Engineering Department
Keith A. Dylewski, P.E., P.S., City Engineer

August 19, 2014

RE: Danbury Woods Site Plan Review

SIDEWALK

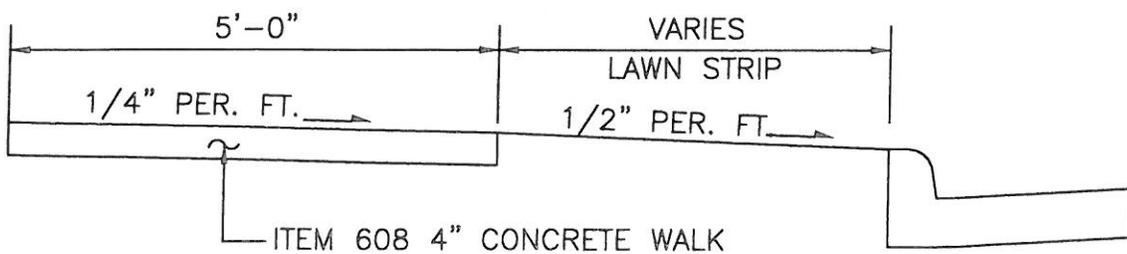
- 1) Provide a copy of the soils report for this project.
- 2) Clearly show and label nearby waterline and location of existing fire hydrants near this site.
- 3) This property applied for and received a zoning change on June 2, 2014 from Massillon City Council. From R-1 single family district to RM-1 Multi Family district. However the plans still reference the old residential zoning. Revise setbacks, notes, and building as necessary to comply with this new zoning classification. The new building setback is 40 feet per section 1157.04 of the zoning code.
- 4) Provide a detail of the new city sidewalk along University drive (see attached)

- 10) Clearly label the boundary between Phase 1 / Phase 2 work.
- 11) Label the size of the existing parking spaces and aisles.
- 12) Is employee count correct? 8 employees per shift for 96 units?
- 13) Install 5-foot-wide sidewalk along University Drive per section 1111.09 of the zoning code.
